Advice regarding 22/3139/FUL - Bank stability and improvement works including sheet pile installation, grading of bank, reinstatement with engineered fill, replacement of concrete surfacing and joints and extended drainage pipe to west and North banks.

Thames Young Mariners Base, Riverside Drive, Ham, Richmond, TW10 7RX

EA Planning Response Document

Document Number: C3123-LAWS-TYM-ZZ-RP-C-0001

Figure 1. Sections Location

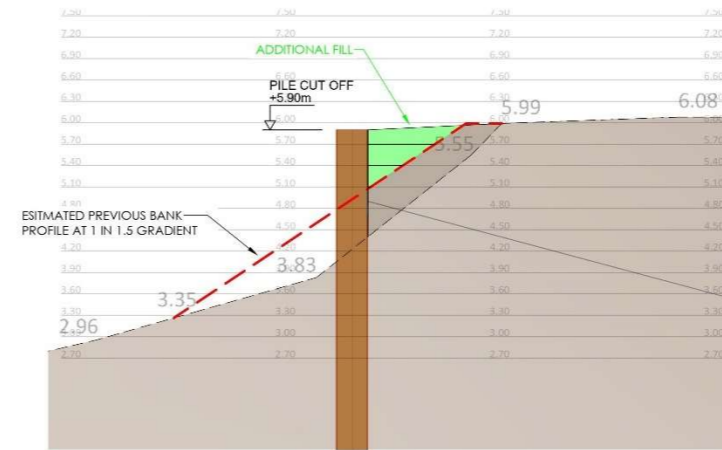
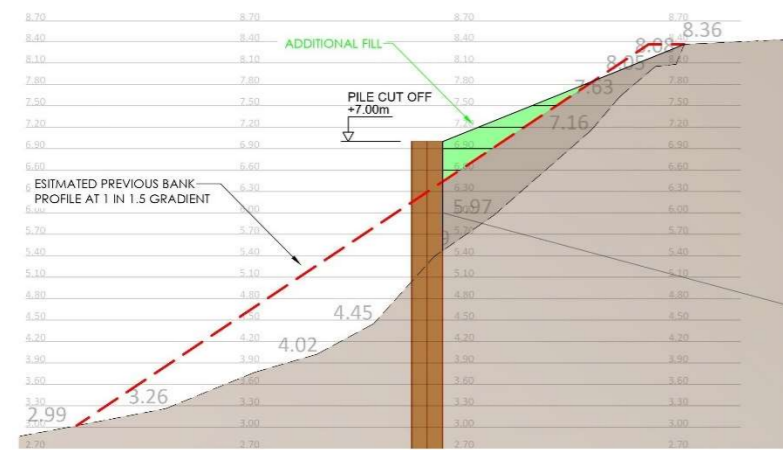
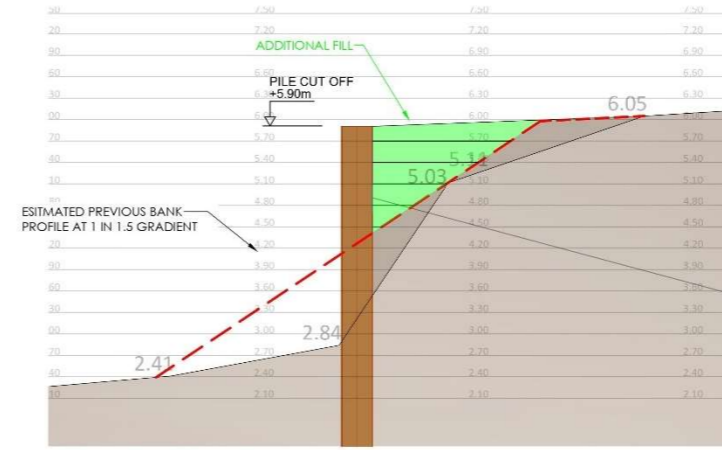
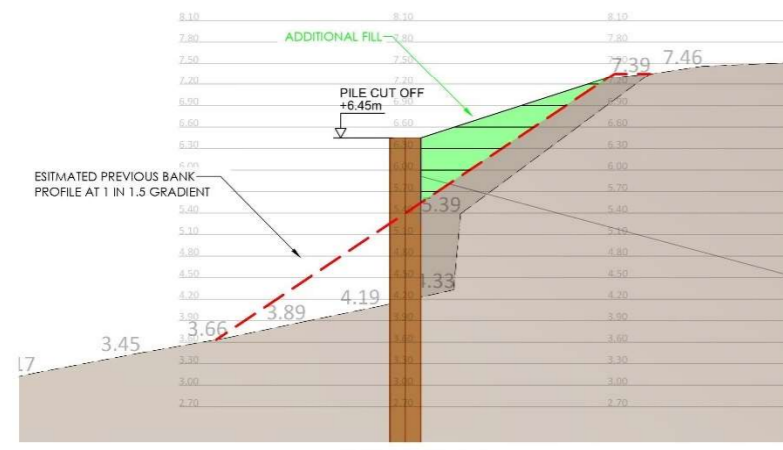
- A plan showing where flood waters are being displaced by the development (i.e. where ground raising is occurring in the floodplain) in addition to a plan showing where the compensation area is located. This should include existing and proposed topographical data for the site.
- It should be clarified at what level (m AOD) the 26.4m³ of material is being removed, instead a wide range of 5.00m AOD to 8.25m AOD currently provided. The compensation volume needs to be at the same level or lower than that of the lost flood storage volume.
- A comparative 'cut n fill' table to demonstrate that level for level flood compensation has been achieved should be submitted to show the potential loss and gain of flood storage for each respective horizontal slice.
- The thickness of each vertical slice should typically be 100-300mm.

A series of sections have been produced at 300mm horizontal slices. The location of these sections can be seen in the below map (figure 1).

Following this, figure 2 provides a table indicating the area occupied within the functional flood plain within each horizontal slice. As well as the volume for each based on the depth as shown in figure 1 for each section.

- Total Volume occupied between 4.20mOD – 7.80mOD: **63.30m3**
- Total Volume occupied between 4.20mOD – 6.9mOD (TE2100 level): **48.86m3**

It was agreed during the meeting that flood compensation is only required below the level of 6.9mOD. Therefore, 48.86mOD of flood compensation is required on a volume for volume / level for level basis.

Figure 3. Flood Compensation Proposal Location

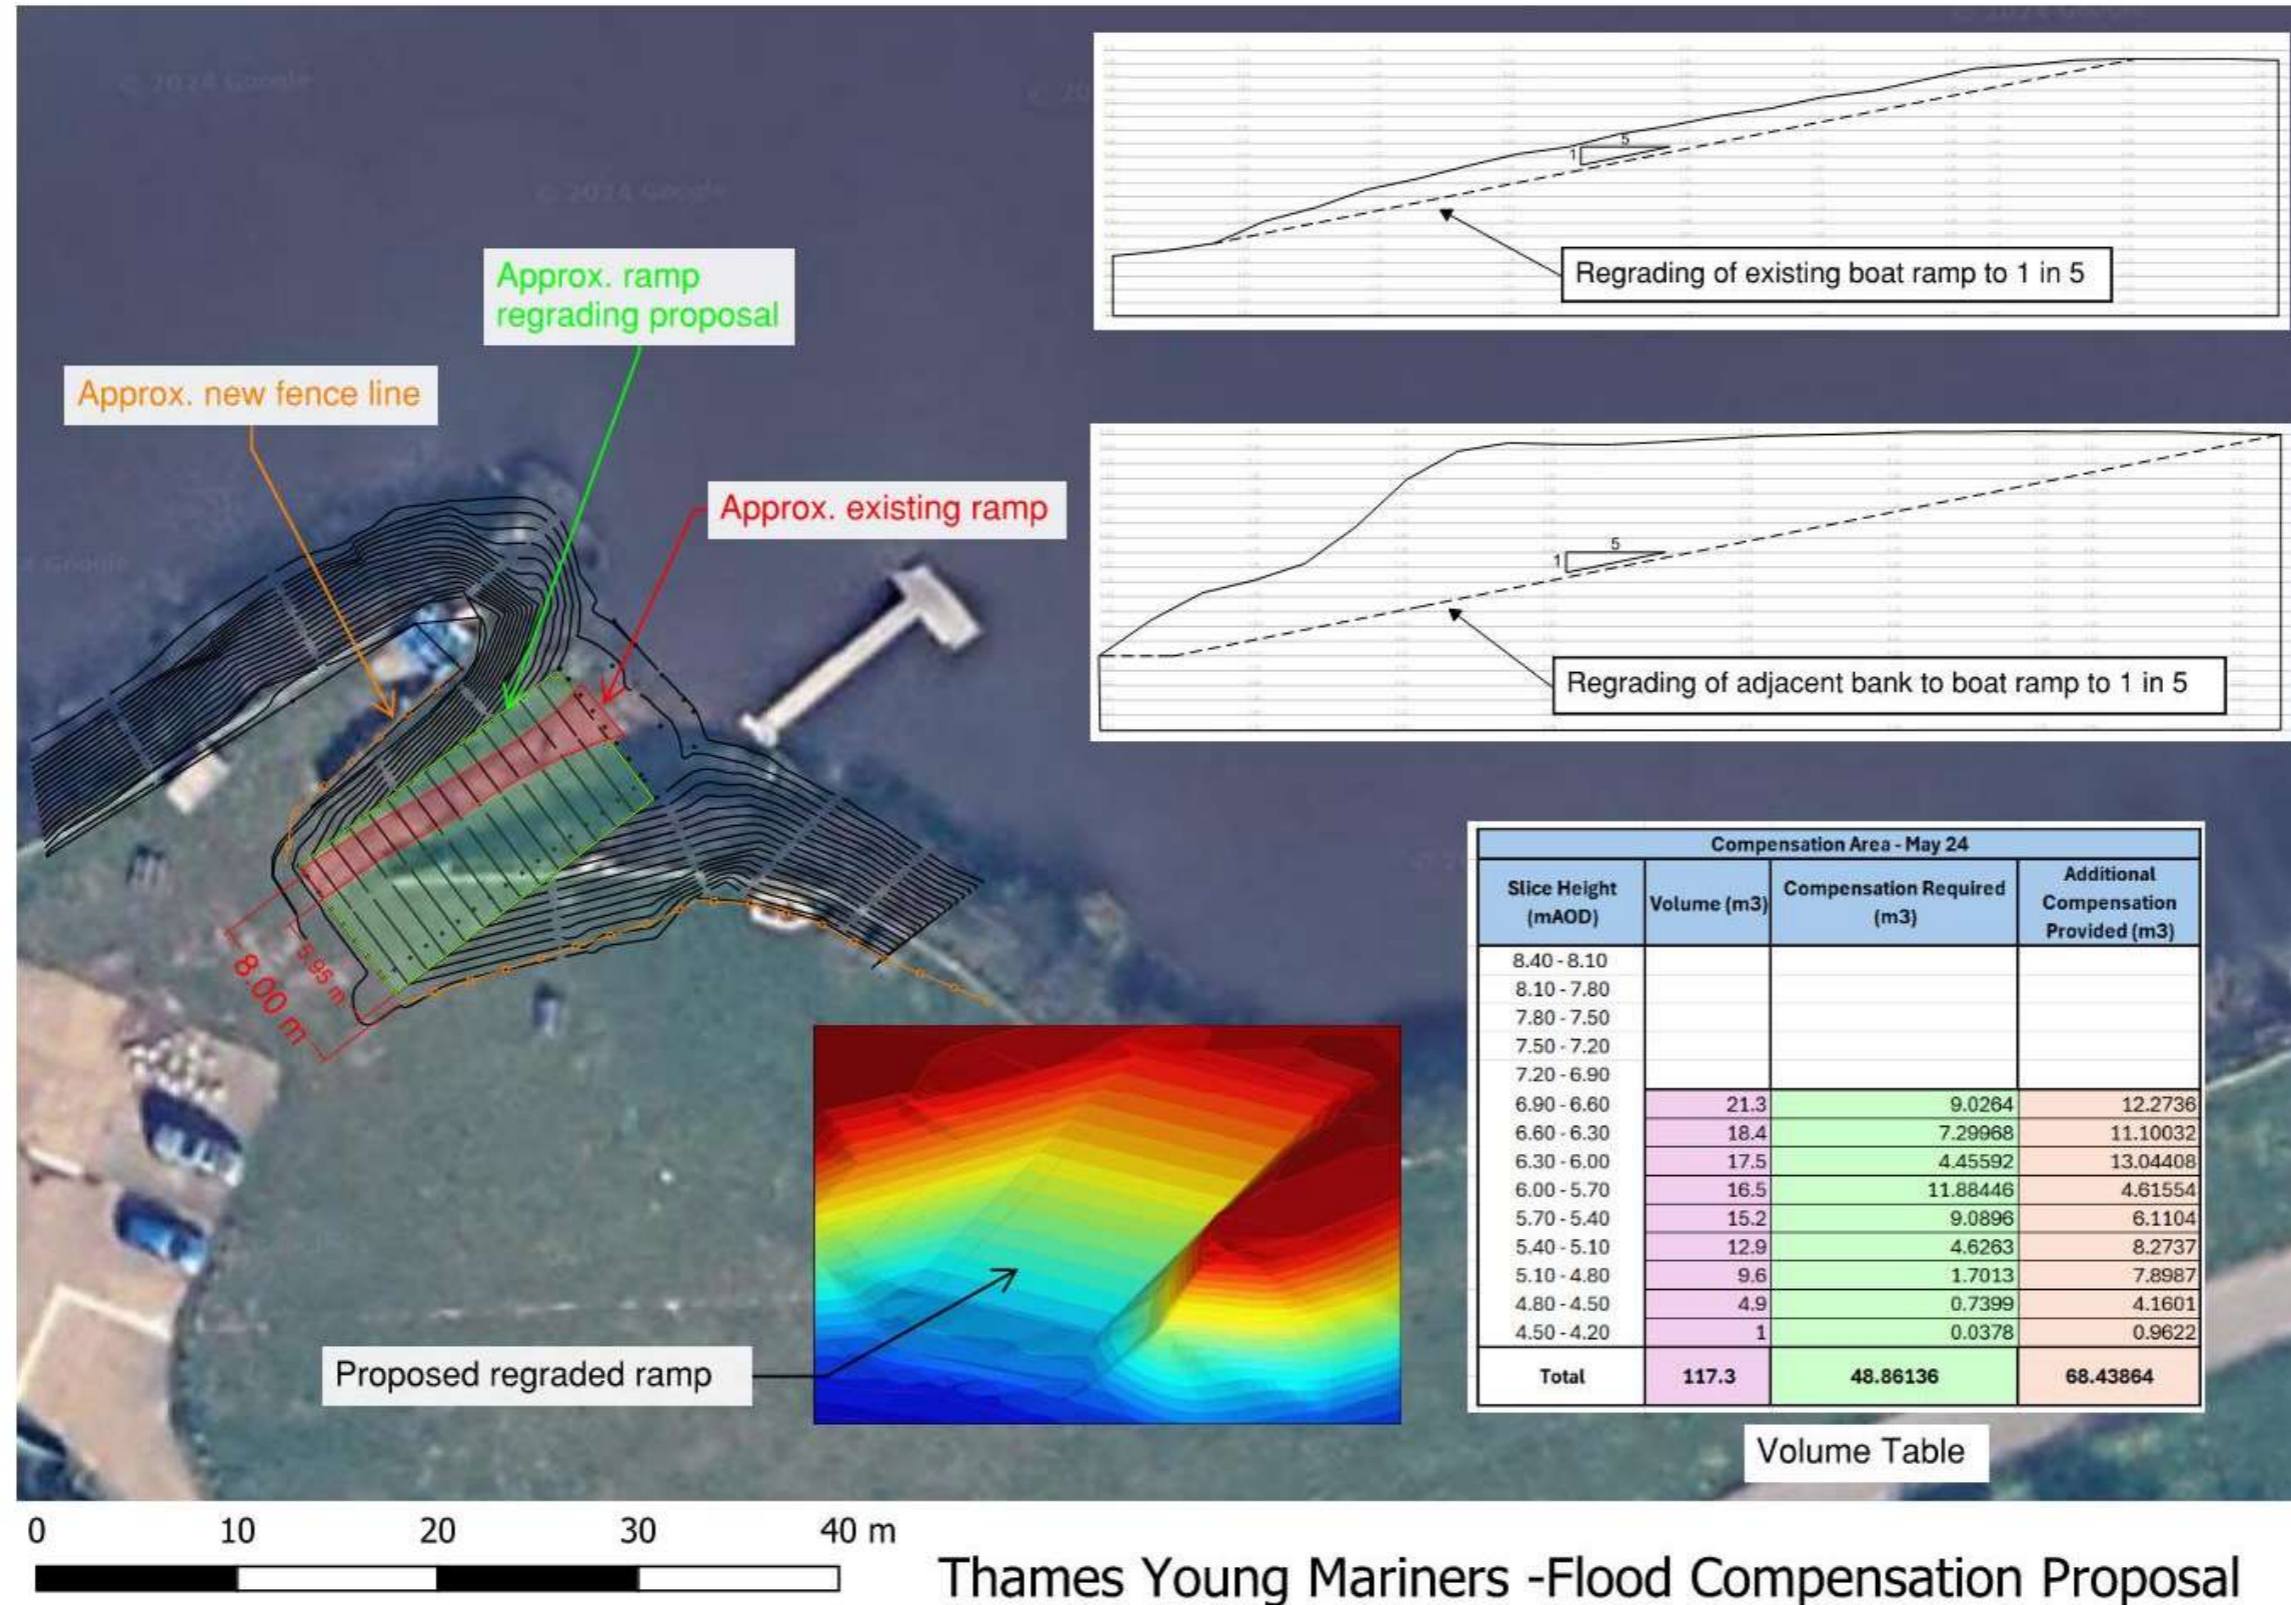
We have reviewed the floodplain statement (ref: C3123-LAWS-ZZ-XX-TN-C-0002) and acknowledge that compensation storage will now be provided. However, further information is needed to demonstrate that the proposed compensation will operate effectively and ensure the proposal does not increase flood risk.

To provide compensation, Land and Water are proposing to widen and regrade the existing on site earth boat ramp.. The proposal is to extend the ramp and regrade the existing slope at a 1 in 5 stable gradient from the toe up to the top of bank. This area of bank has been chosen as it occupies levels between 4.20mOD – approx. 7.6mOD which is within the required range to provide compensation within. The below figure details the location of the proposed compensation location as well as a section taken through the bank using LiDAR data.

To inform the flood compensation calculations, a topographical survey was undertaken on site to provide detail around the boat ramp. The new proposed bank regrade was modelled to meet the required flood compensation provision. During the modelling process it was determined that the boat ramp will require a typical extension of 6m. The below figure presents the proposed regrade and flood compensation volumes within a table.

3.2.1 2014 Maximum Likely Water Level

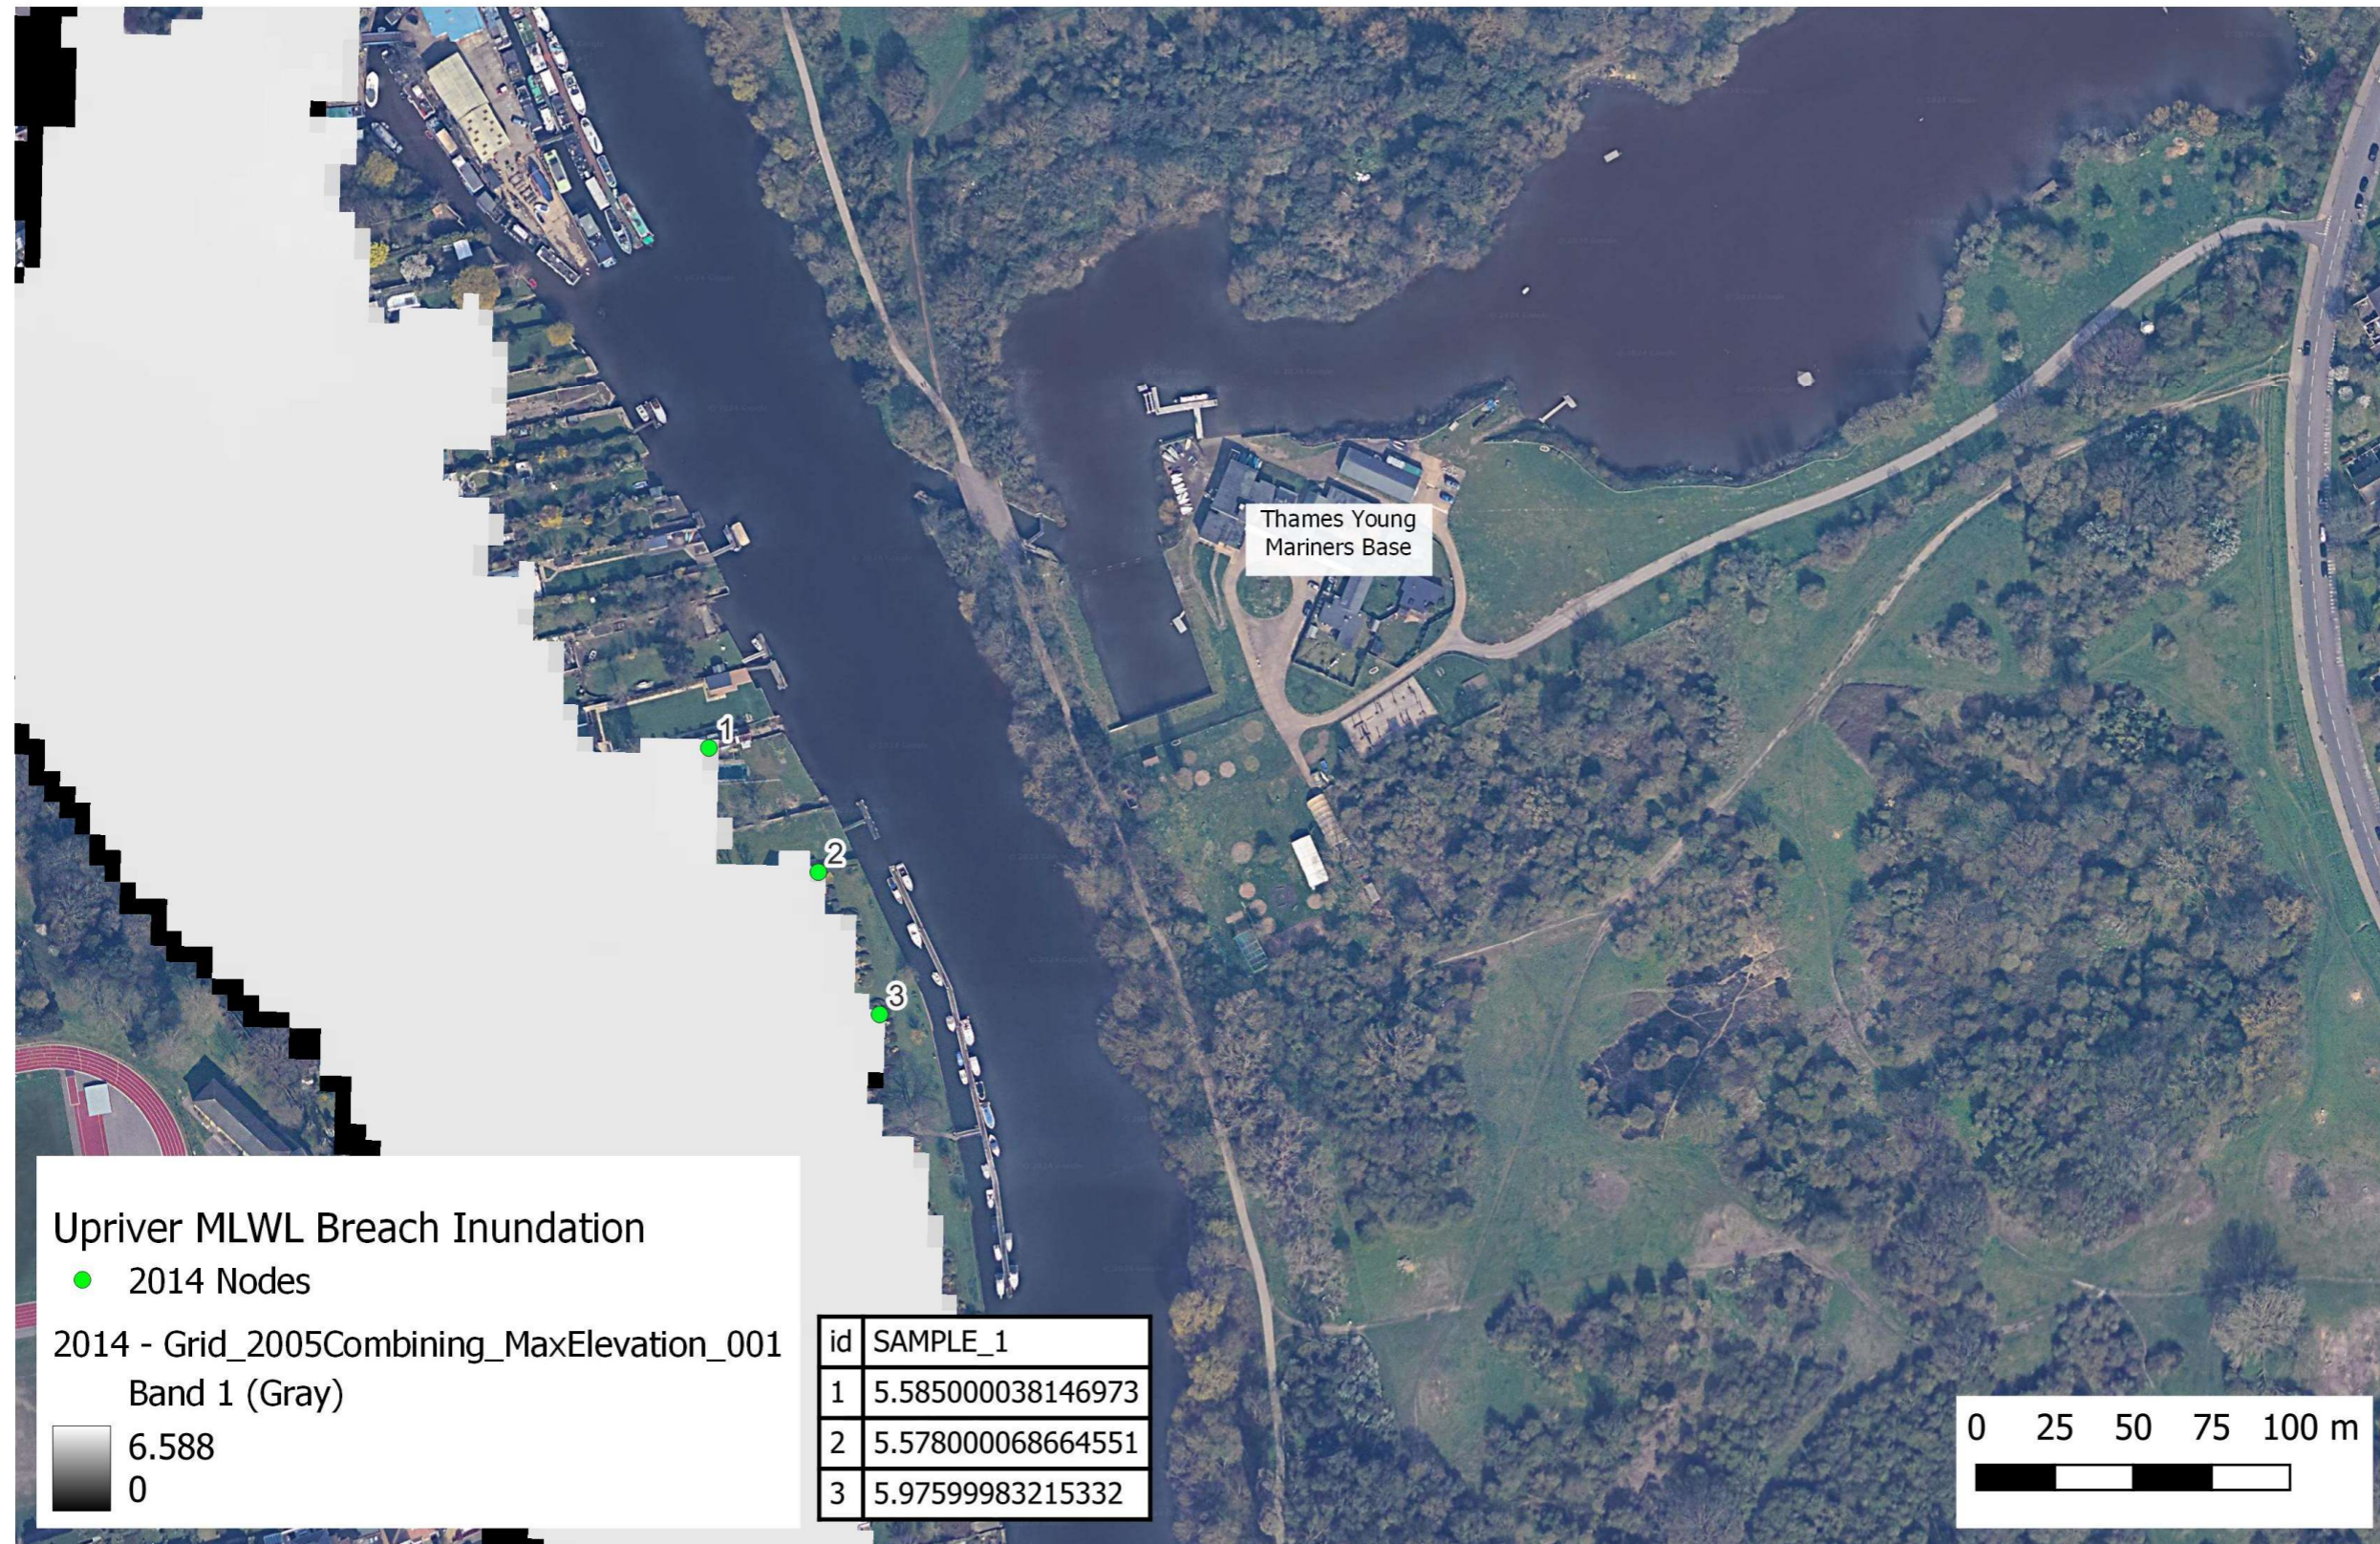
As raised in our formal response to this application dated 2 February 2024 (ref: SL/2023/123082/01-L01), a revised FRA should be informed by our Thames Tidal Upriver Breach Inundation Modelling [2017] and Lower Thames, Jubilee River and River Ash Modelling Study [2020].

Data was requested and received. The relevant elevation 2d grid data was overlaid onto QGIS. Points were plotted onto the data at the closest location to the Thames Young Mariners base as not all of the data covered the site.

The points were used to extract / sample data at each location, a map for each of the sample data has been produced below which includes the point location and extracted / sampled data table.
